RE: BIRCH ROAD WELLFIELD REDEVELOPMENT & WATER TREATMENT PLANT
EOEA #14197 DEIR

I appreciate this opportunity to submit written public comment for the proposed project titled "Birch Road Wellfield Redevelopment & Water Treatment Plant," EOE #14197, located in Framingham, MA.

NHESP Biomap for Wayland and Framingham at Birch Road.⁵

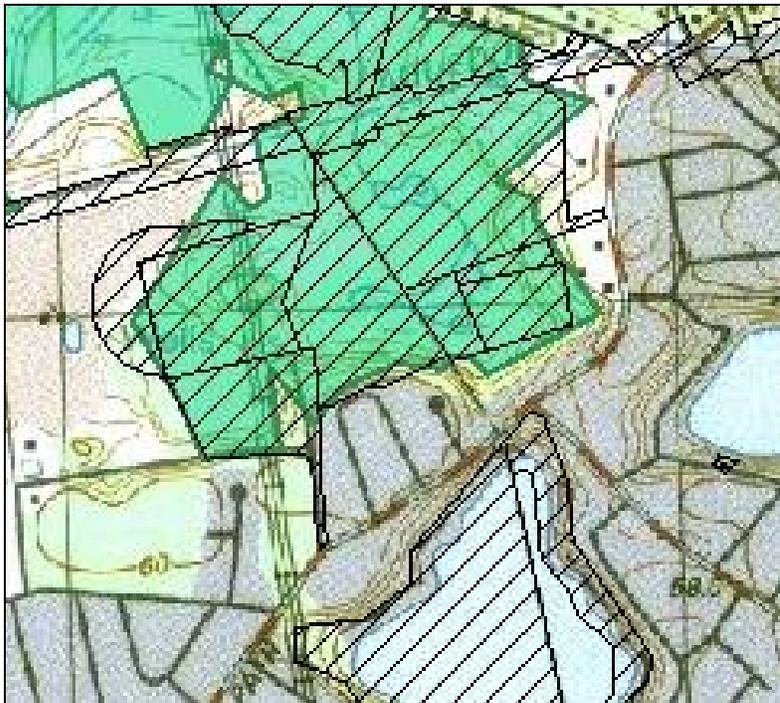
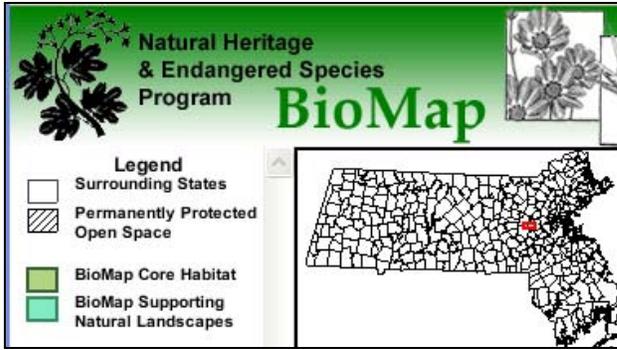
While it is technically correct to state that “there are no areas of Priority Habitat or Estimated Habitat associated with the site”, the site directly sits on an important “Supporting Natural Landscape” to the Core Habitat endangered species area at Great Meadows NWR on the “Wild and Scenic” Sudbury River some 700 feet to the north.

These “Supporting Natural Landscapes” are most directly associated with the swamps and wetlands located between Birch Road and the Sudbury River, and the NHESP BioMap clearly indicates the surface streams flowing from Birch Road through these wetlands.

Birch Road Wellfield is clear circle at bottom of map located in the NHESP *Supporting Natural Landscape* that connects to the NHESP *Core Habitat* to the North. Happy Hollow wells # 1 and # 2 are in located in the hatched circle at the upper right of map West of Wayland High School.

Sudbury River runs out of water in Framingham.
Dry Sudbury River bed, Aug 1999 below, full bed Oct., 2000.

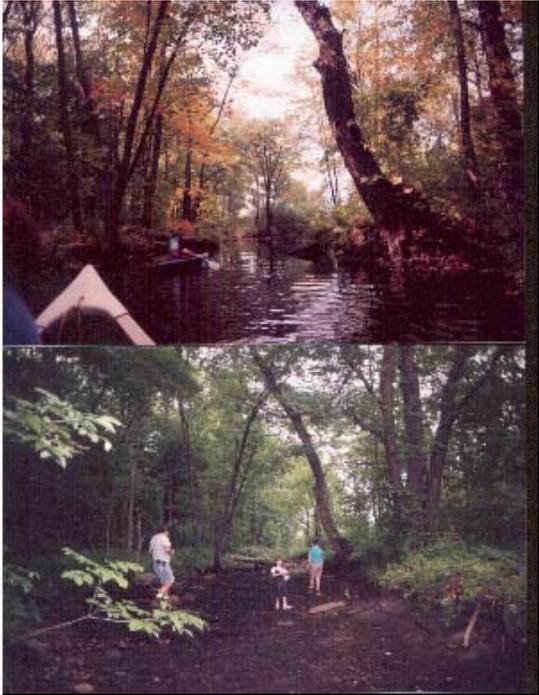
The Sudbury River: Is located just over 2,000 feet to the north and Northwest of Birch Rd wells, with highly permeable sand intervening.

Wayland Earth Tech AECOM Study of Well Capture Zones – 2008

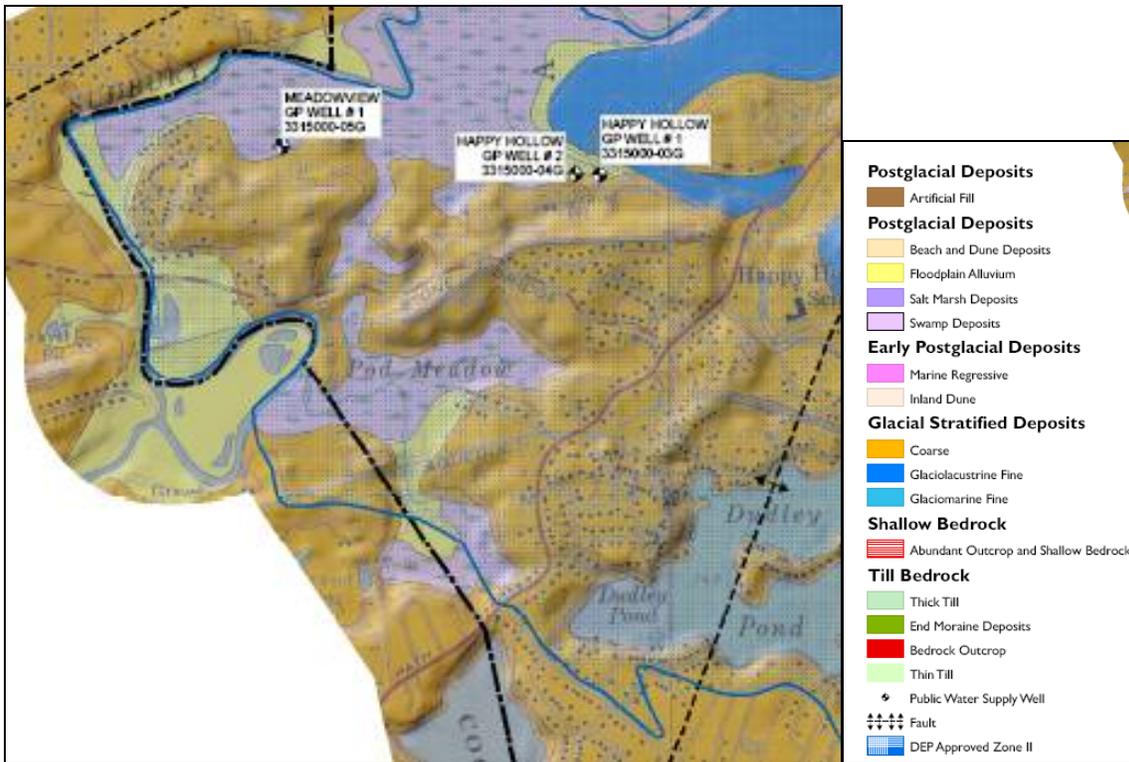
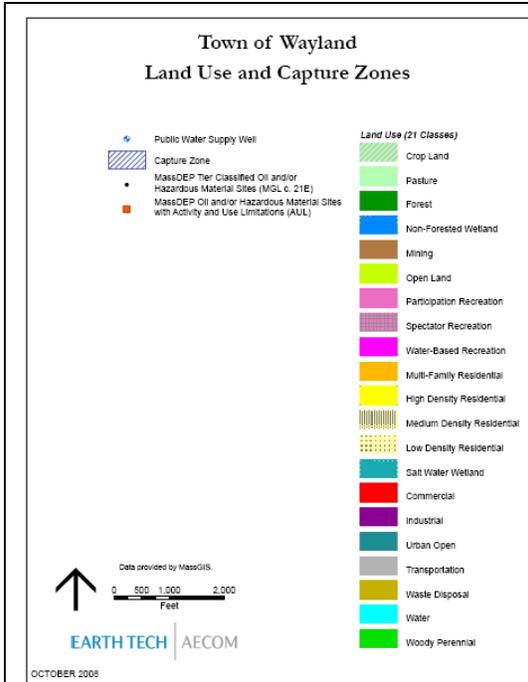
Below are graphics from the Earth Tech report indicating the capture zones of the Meadowview Well #1 (currently offline) and Happy Hollow Wells # 1 & # 2. The Framingham Birch Road wellfield is noted at the bottom of the graphic, without the delineation of the capture zone.
